Recall Bulletin

SUBJECT: Safety Belt Buckle Anchor Fracture

MODELS: 2011 Cadillac SRX
2011 Chevrolet Equinox
2011 GMC Terrain

The Service Procedure in this bulletin has been revised to correct the model name in the second bullet under Step 1. Please discard all copies of bulletin 10370, issued December 2010.

2545470

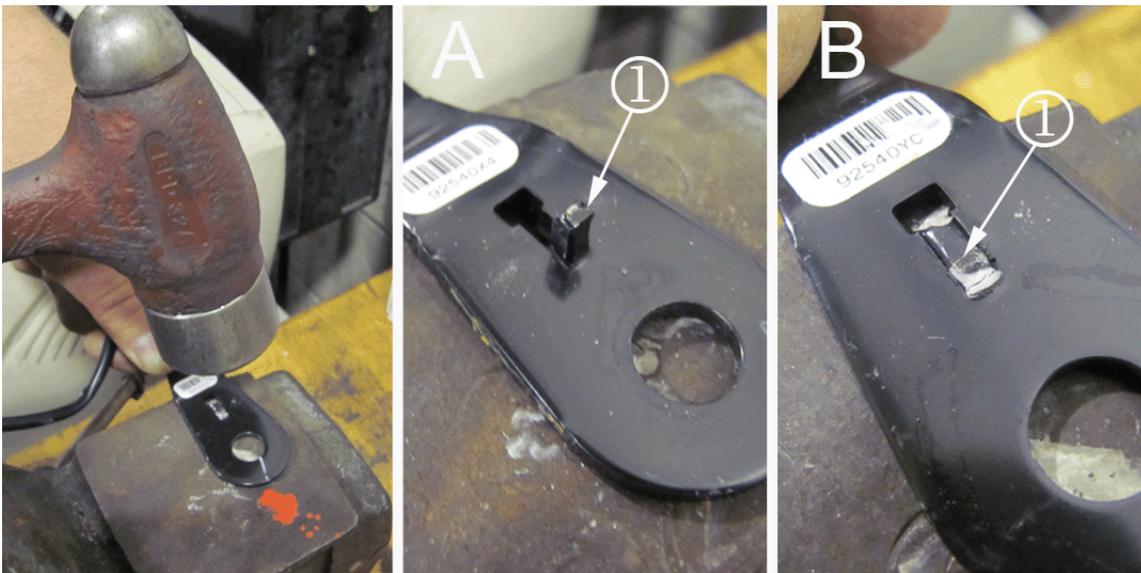
Note: The seat belt buckle assembly angle must be marked with a marker prior to removal so that the seat belt buckle assembly alignment is correct on reassembly.

3. Use a marker to highlight the edge of the seat belt buckle assembly to the seat frame. Refer to illustration.
4. Remove the seat belt buckle assembly and place it on a work bench or vise.
